RENESAS TECHNICAL UPDATE

Product classification	MPU & MCU	Document No.	TN-V85-A027A/E	Rev.	1.00
Title	Document Modification of Standard Self Programming Flow		Notification classification	Technical Information	
Affected Products	In the main part	Affected production lot	Related documents	User's Manual : Hardware of affected products	
		All lots

Standard Self Programming Flow

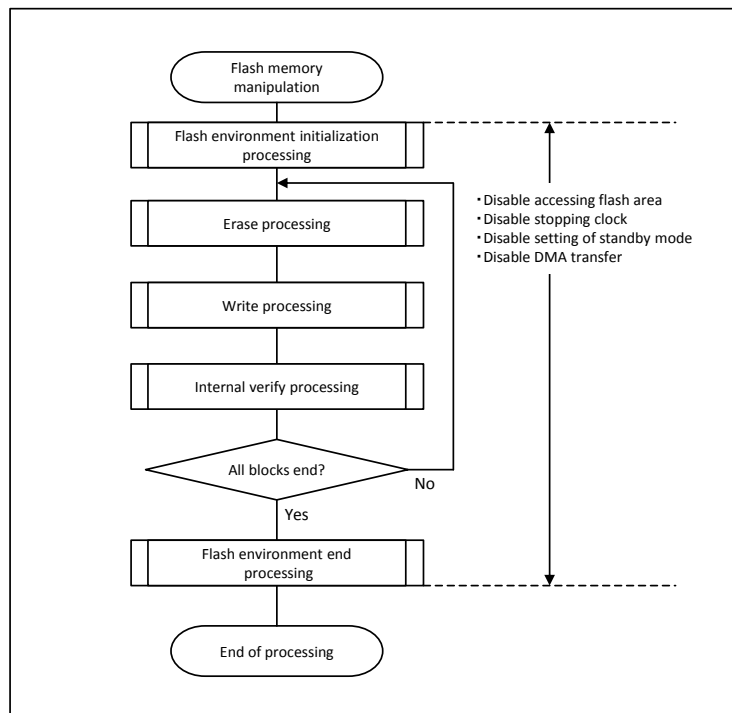
In the User's Manual: hardware of V850 Series on the following 2.Affected Products about a standard self-programming flow of the flash memory, we correct it as follows, because there is an error of description about the prohibition of the standby mode.

We correct from "Disable setting of standby mode other than the HALT mode" to "Disable setting of standby mode".
